SEABROOK STATION STEAM GENERATOR TUBE RESPONSE

DURING SEVERE ACCIDENTS

DECEMBER 5, 1986

DRAFT

FIG. 1 STEAM GENERATOR INLET
PLENUM TEMPERATURE COMPARISONS

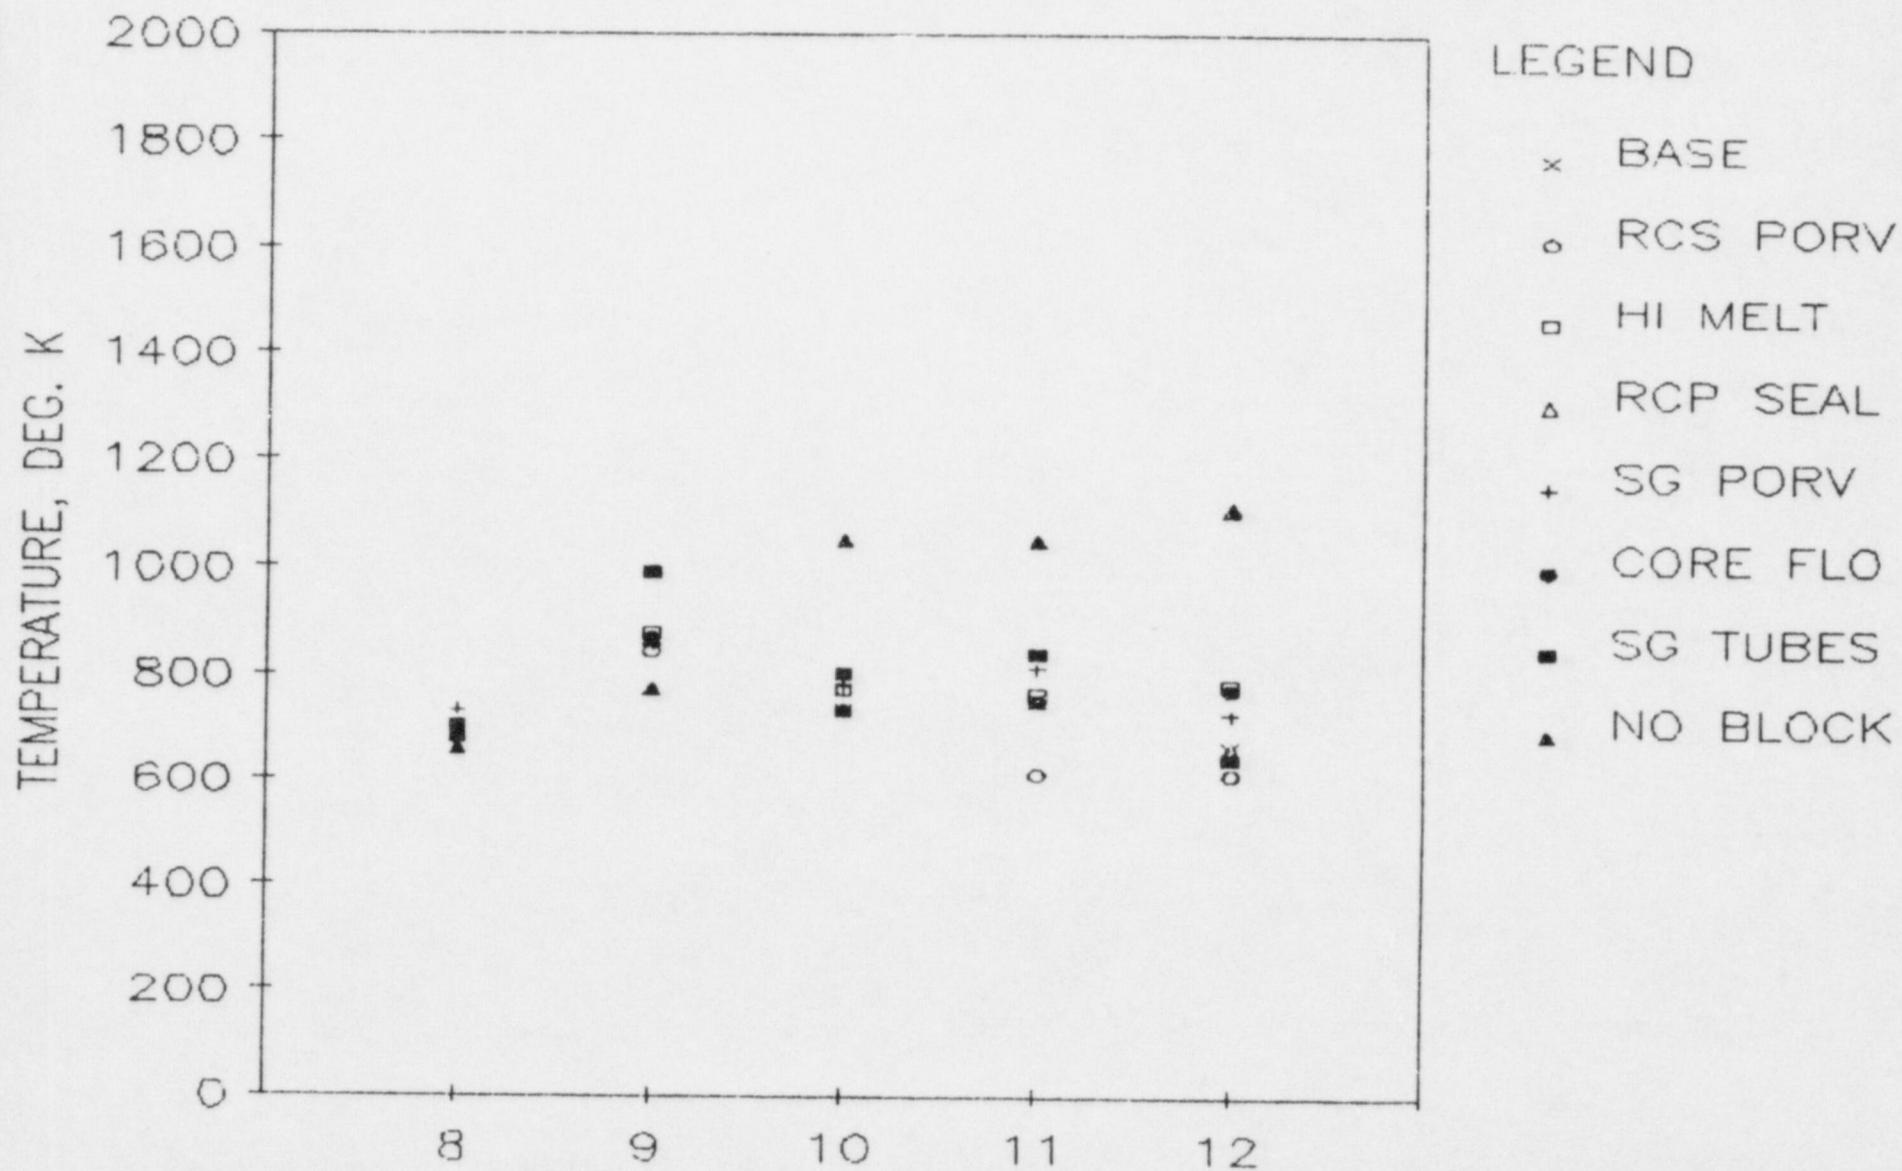
- g. Sensitivity Summary. An approximate comparison of the results of the sensitivity study is provided in Figure 1. The major early effect on increased tube temperature is due to changing the SG tube flow characteristics. Later, and with the greatest impact, is the effect of delaying formation of blockage in the core, which allows continued circulation of hot fluid through the core where the temperature is increased, as opposed to a drastic reduction in heat transport between the core and other RCS components when a core geometry change occurs.
